Re: Proffer Interpretation for RZ 2001-SU-044, Sully Manor: rear yards for single family attached units

RE: Sully Manor – Section 1
Request for Letter of Interpretation (RZ 2001-SU-044)
Project #005002.05

TYPICAL LOT LAYOUT: SINGLE-FAMILY ATTACHED

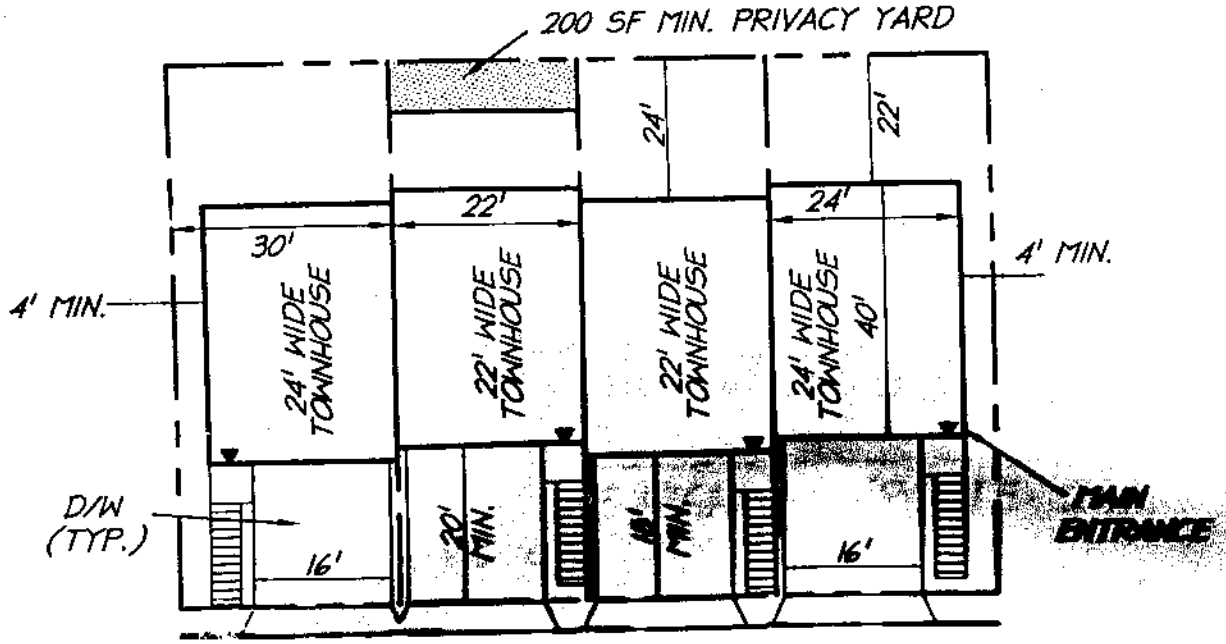
The proffered CDP/FDP shows a typical layout for the single family attached units that indicates minimum rear yard dimensions of 22' and 24' for units that would have 20' and 18' front yards, respectively, in order to allow for driveways and staggered 2' architectural jogs in the individual units. The typical also shows a 40' long unit which would, in combination with the yards, equate to a lot which would be 82' in length.

You indicate in your letter that lot lengths were intended to be 80' and a site plan has been submitted and approved by DPWES that includes a majority of lots at that length. You opine that there is a conflict on the CDP/FDP between the typical layout shown on Sheet 1 and Sheet 4 which shows lots that, while not specifically dimensioned, scale to 80' in length.

Relative to the specific issue at hand, the approved CDP/FDP has some conflicting information. The conflict appears on the cover sheet and focuses on the typical town home lot layout described above (copy included for reference). The detail is entitled: "typical lot layout: single-family attached" not drawn to scale and so noted. When you add the 22' rear dimension to the 40' house footprint and a 20' front yard, the lot would need to be 82' deep. All of the town home lots on the CDP/FDP site plan sheet (sheet 4) were designed at and scale to 80' (with an exact dimension in the computer as 80.8' to allow room to provide brick fronts as required by proffers). In addition, the units shown on the CDP/FDP all scale and were intended to be 42' in depth. Hence we have a conflict between the typical section on the plan cover sheet and the layout on the plan sheet.

The builder is planning on providing a product that has proved popular in this area and very compatible with the local neighborhoods and meets the needs of the typical town home purchaser. The minimum length of that unit is 40'. The most popular option on these types of units is the 2' extension on the overall length making the total unit depth 42' in conformance with the unit shown on the approved CDP/FDP. This extension is anticipated to be requested on approximately 90% of the units sold (of the 81 townhomes on this project, 50 have already been sold). In the event a purchaser selects all possible options, a rear yard dimension of 18' and 20' will exist.

The rear yards on the site plan in bonding are 18' and 20'. The yard was not an issue during site plan review and approved. The rear yard provides much more than the required 200 S.F. minimum privacy yard. The privacy yard provided with the largest optional extension (shortest rear yard scenario) measures 396 square feet which far exceeds the minimum privacy yard of 200 square feet.

In closing, we never intended the dimension on the sketch to be viewed as a minimum rear yard and are hopeful that given the inconsistencies within the approved CDP/FDP that this interpretation will be favorably viewed. I am enclosing a copy of the CDP/FDP and the proffers for your convenient reference as well as a detail showing the actual unit footprint on the town home lots which conforms to the approved site plan. I would appreciate your review and approval of this request as an interpretation of the proffer conditions and the CDP/FDP.

It is my determination that the typical minimum yard dimensions shown on the proffered CDP/FDP for the single family attached units would govern. Further, it is my determination that the reduction of 2' in the rear of the single family attached units such that the minimum required rear yards would be 20' and 22' (depending upon the staggered front setbacks) would be in substantial conformance with the proffers and the CDP/FDP. It is my determination that a 4' reduction in the minimum required rear yard for the single family attached units would not be in substantial conformance with the proffers and the CDP/FDP. These determinations have been made in my capacity as the duly authorized agent of the Zoning Administrator.
